Terran Corporation

February 1, 2018

RE: Technical Report Review: *"Evaluation of Groundwater Impacts, Dewatering of Proposed Enon Quarry, Clark County, Ohio"*

Figure 1. Specific capacity frequency graphs for wells near the proposed quarry pits in Mad River Township compared to ODNR (1970) wells in northwest Ohio.

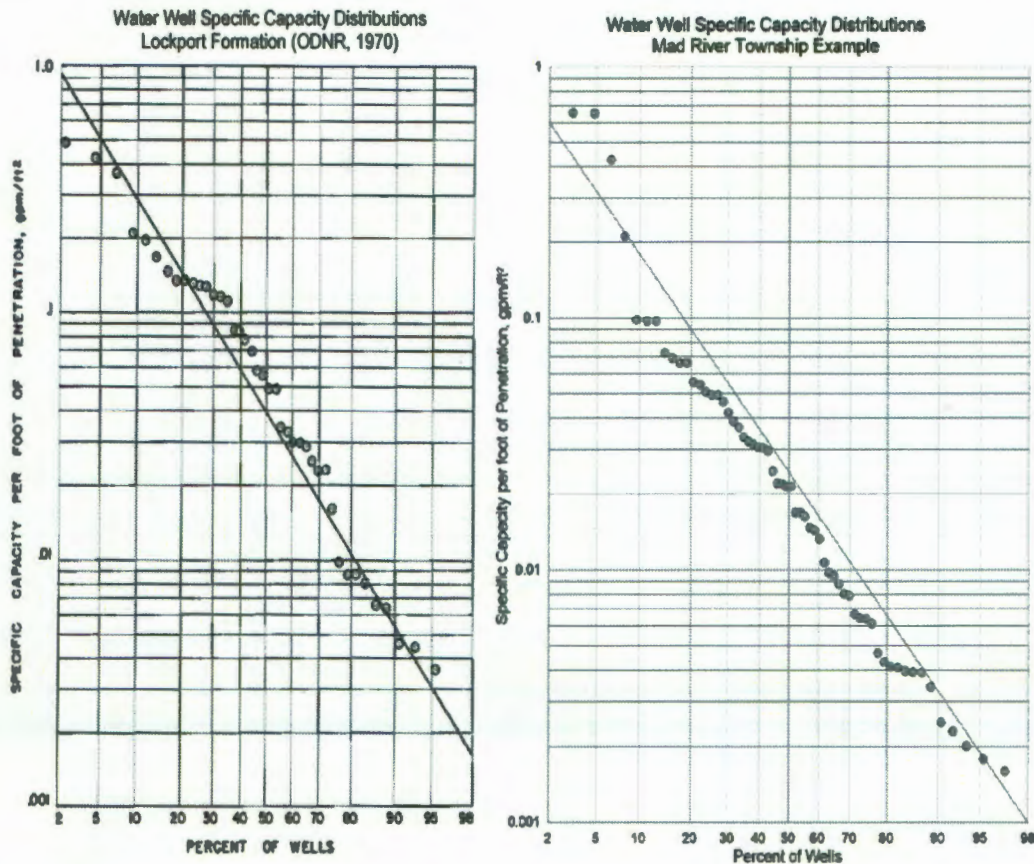
Using a subset of 69 water wells near the proposed quarry operations in Mad River Township, a graph was developed using the calculated specific capacities normalized by the length of open hole exposure. This is compared to the same graph developed by ODNR (1970) for wells completed largely in the Lockport Formation (Figure 1).

What should also be noted from this comparison is both graphs presented in Figure 1 show the highest specific capacity values for about 20% of the wells in the data set. According to Smart et al. (1992), those higher capacity wells would represent groundwater flow from fissures and well connected fissures in the carbonate aquifer. Furthermore, the average specific capacity per foot of penetration for the wells in the ODNR (1970) investigation was approximately 0.038. For Mad River Township wells nearby the proposed quarry pits, the approximate average for specific capacity was 0.025, indicating the groundwater production potential will be virtually the same. This follows well the groundwater flow conceptualization discussed by Podgorney & Ritzi (1997) for the Sub Lockport formation.
